# Memorandum

Subject:

Variance Request for an existing septic system, SNHD Permit #: ON0031210, located at 6075 Starlight Dr, Las Vegas, NV to: 1) remain installed under an unpaved driveway; and 2) allow the existing trees to encroach on the septic system.

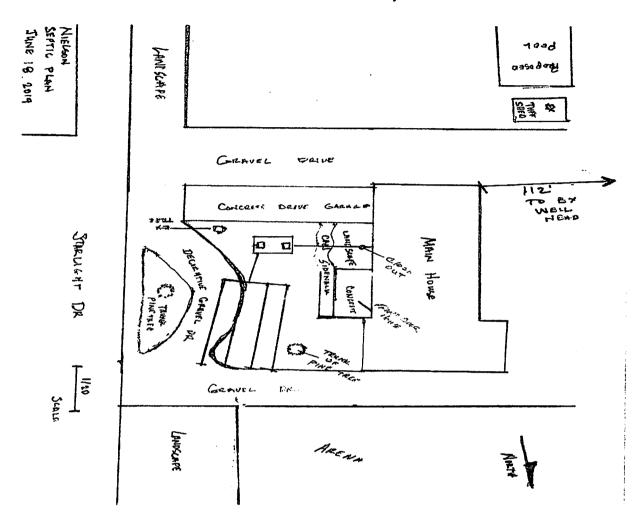
Next I hired a vacuum truck equipped with a camera and locator to excavate down and find the exact tank and leech field location. The septic tank itself is a standard 1250 gallon tank that fully meets current specifications. We then located each leech line and sent the locator and camera down searching namely for tree roots, but also any other obstructions or blockages. None were found as all lines were clear. (I have attached photos of all the exploratory findings in this email.)

Our desire is certainly to be in compliance with all statues and regulations. However, I feel an exception is warranted in this case. The tree base is 3 feet outside the leach field. The tree has been there since the existing house was built in 1992. We have determined that, in the preceding 27 years, no rooting has occurred into the leech field. The tree provides ample shade and makes the property much more appealing and enticing for the benefit of the area and community. It would be imprudent to remove it for no cause. If, in the future it becomes problematic, I would then have a differing opinion and gladly remove it. As for the half-circled driveway, this is intended for decoration only. It is too small and not intended for motor vehicle access.
